**Bid Title:** P.O. Hoffer Water Treatment Facility Glenville Lake Water Treatment Facility Post-Filter GAC Adsorption Facilities Contract No.67

**Addendum Number:** 4

**ADDENDUM NO. 4 – TECHNICAL SPECIFICATIONS AND DRAWINGS**

**Project:** P.O. Hoffer Water Treatment Facility and Glenville Lake  
Water Treatment Facility – Post-Filter GAC Adsorption  
Facilities – Contract No. 067

**RTU-7**  
RISER DIAGRAM

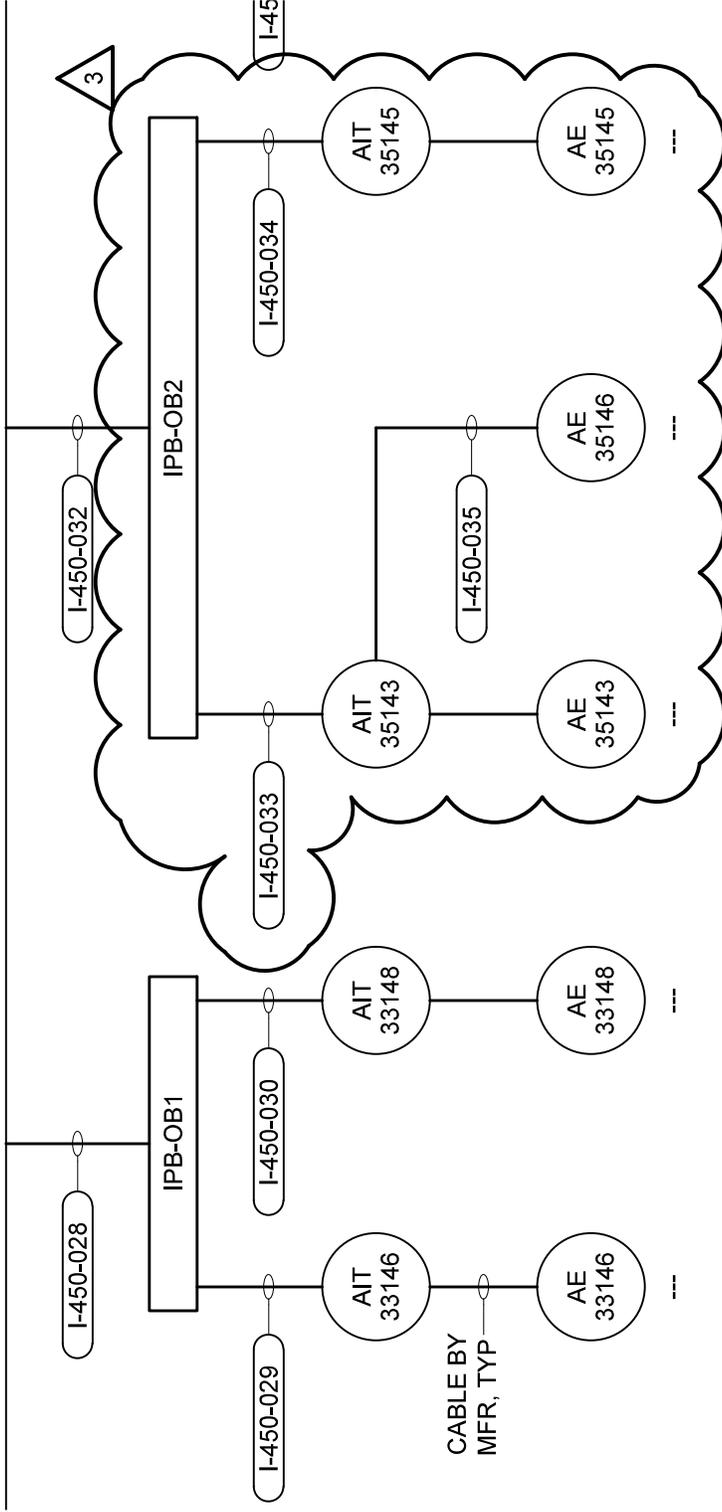
- E453 Revised RTU-7 riser diagram to remove AIT-35143 and connect AE-35146 as shown in **Attachment #16.**
- E455 Revised conduit and wire schedule to remove "VIA DISCONNECT SWITCH" from the descriptions for conduits P-450-056, P-450-057, P-450-061, P-450-062, P-450-066, P-450-067, P-450-071, P-450-074. Added FIT-35142 GAC Feed Pump Flow wire and conduit to conduit entry P-450-085 as shown in **Attachment #17.**

**FLOW TRANSMITTER**  
RISER DIAGRAMS

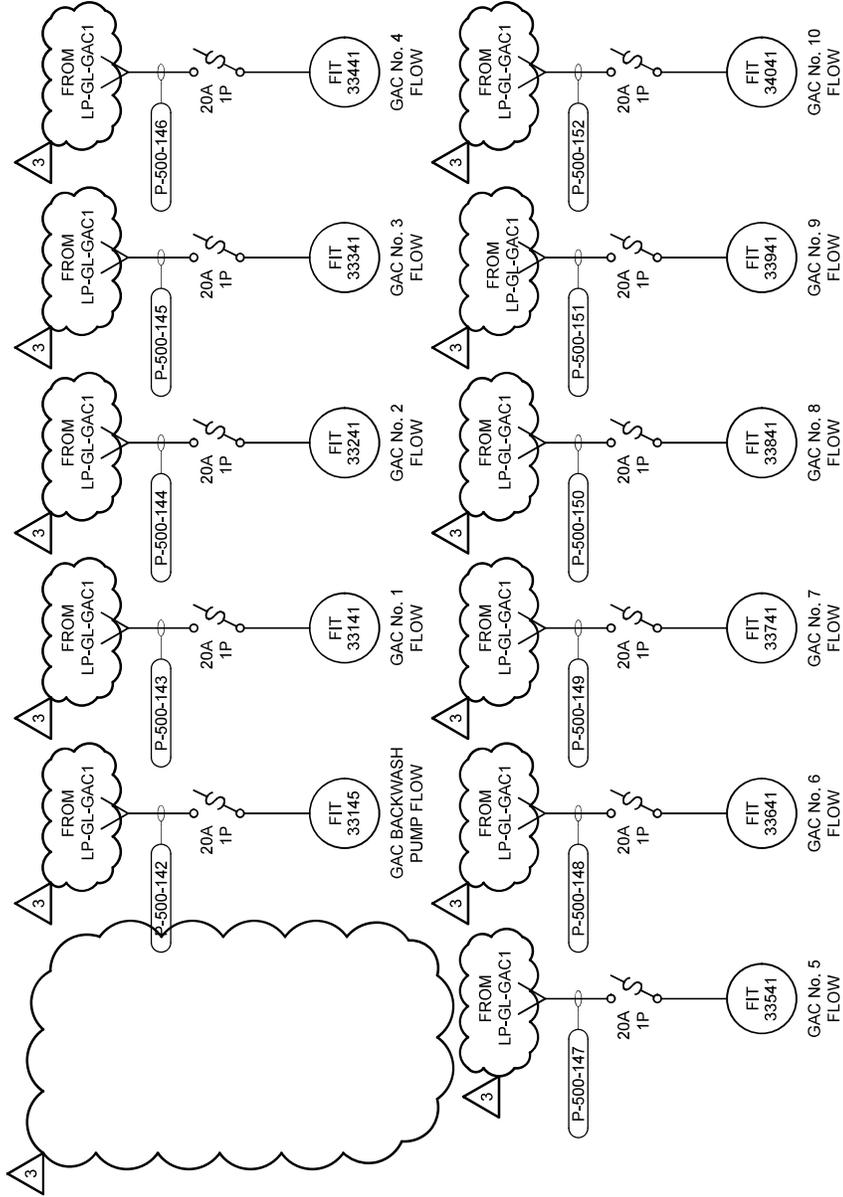
- E508 Revised Panel Schedule LP-GL-GAC1 to remove contents from circuit #5 and make and revised to make it spare as shown in **Attachment #19.**
- E510 Removed FIT-35142 from the Flow Transmitter riser diagrams. Revised Flow Transmitter circuits to be supplied from LP-GL-GAC to LP-GL-GAC1 as shown in **Attachment #20.**

**LEVEL TRANSMITTER**  
RISER DIAGRAMS

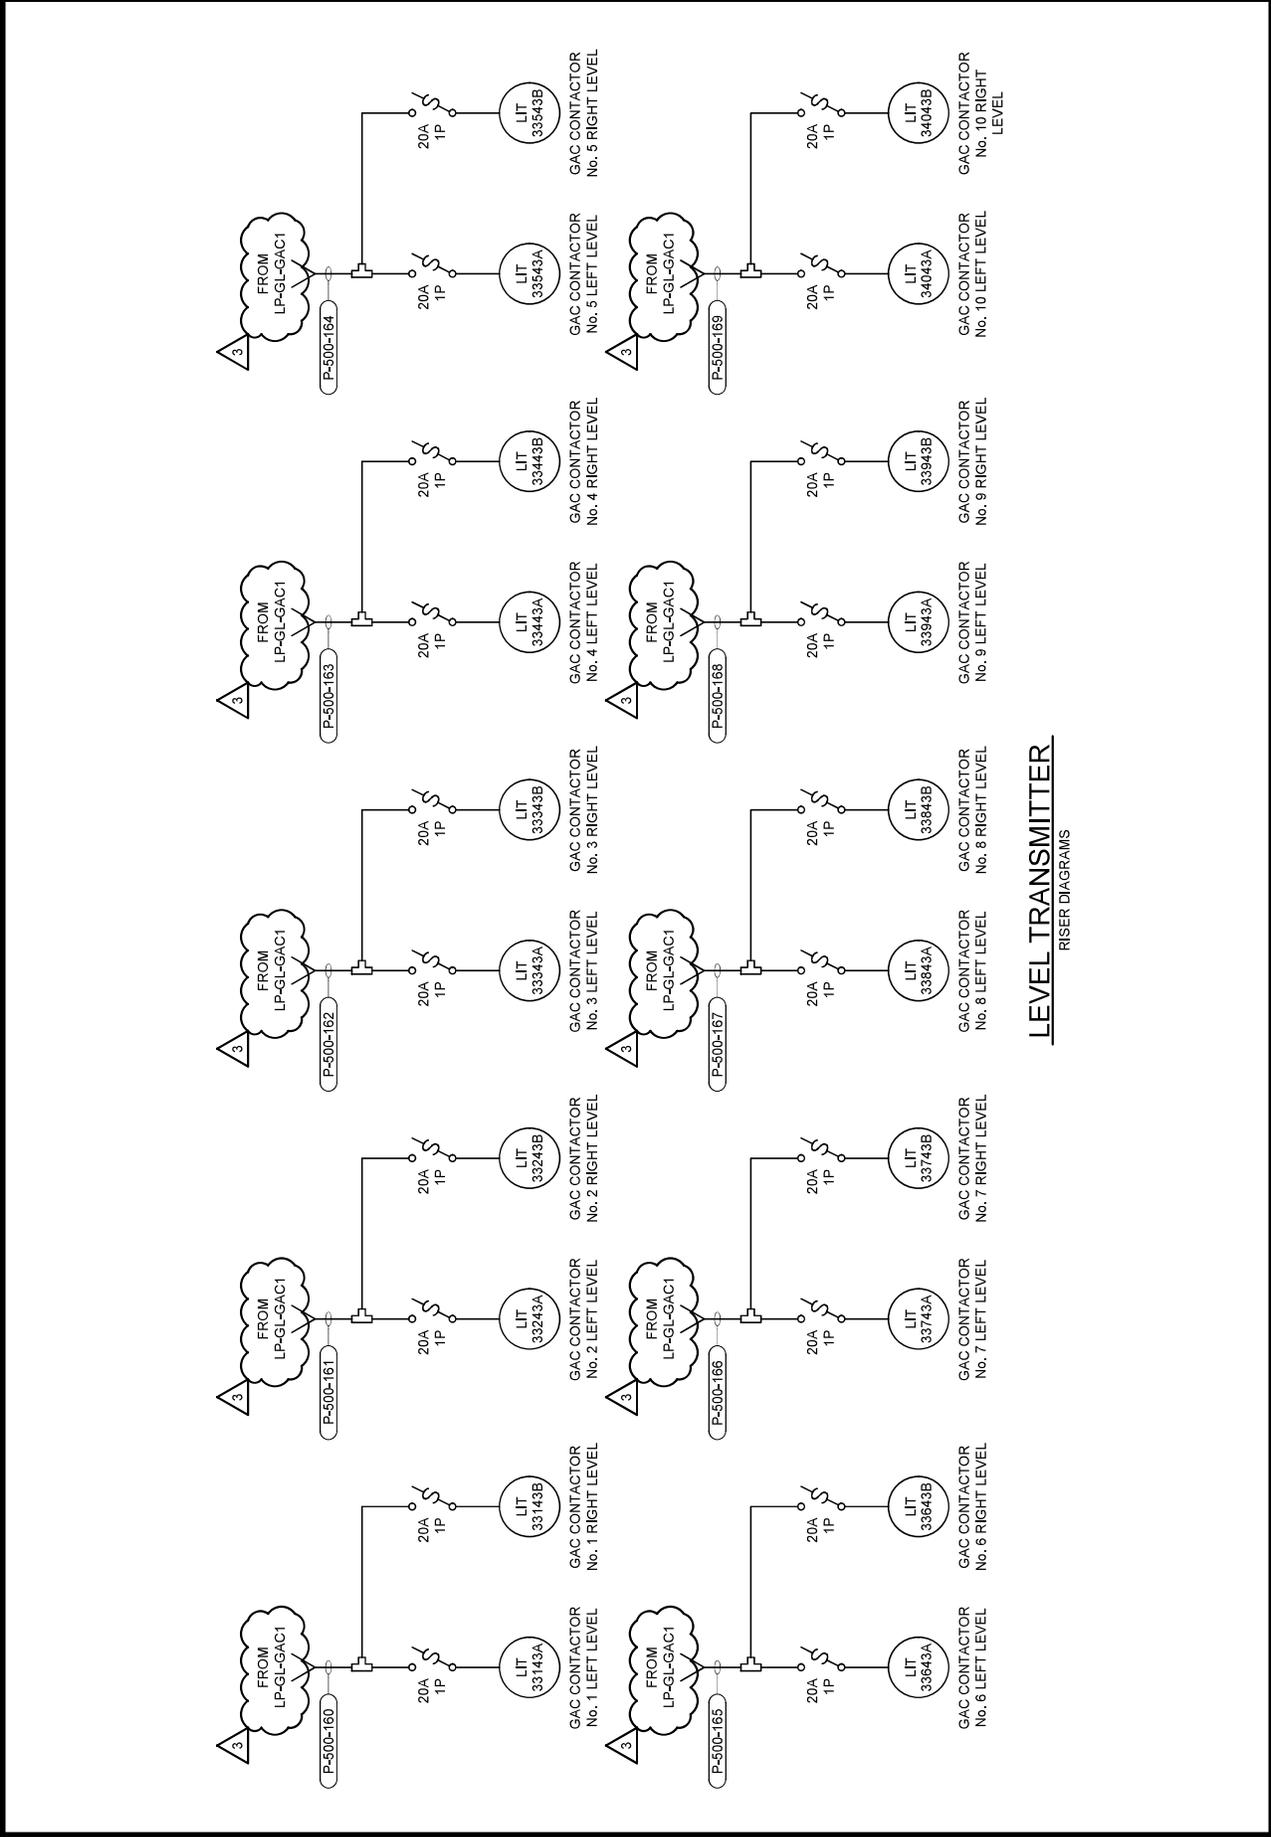
- E510 Revised Level Transmitter circuits to be supplied from LP-GL-GAC to LP-GL-GAC1 as shown in **Attachment #21.**
- E519 Removed FIT-35142 GAC Feed Pump entry from conduit P-500-141 as shown in **Attachment #22.**

**SECTION F**  
1/4" = 1'-0"  
S101

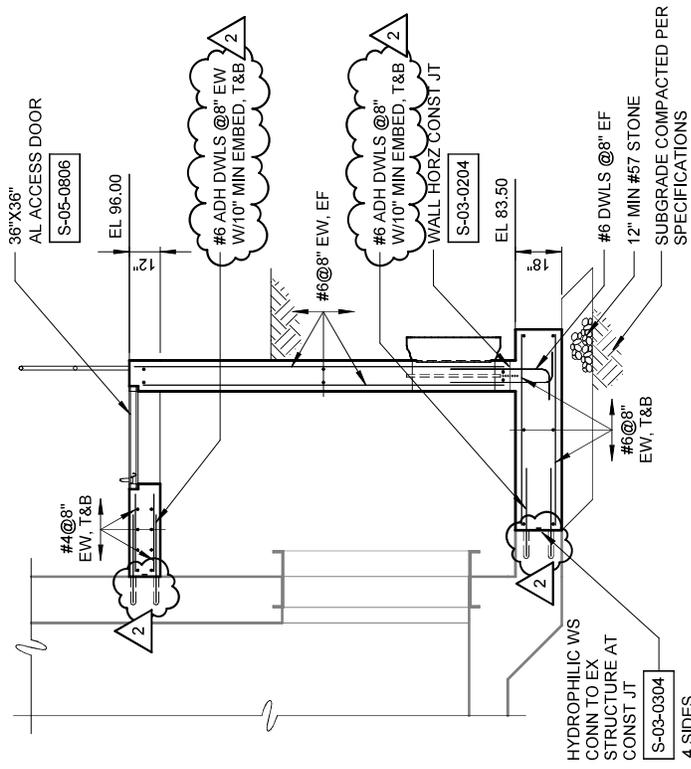
- S102 Revised adhesive anchor embedment in SECTION F, included in **Attachment #24.**
- S300 Revised concrete divider wall thickness in BOTTOM PLAN and SECTION E, included in **Attachment #25.**
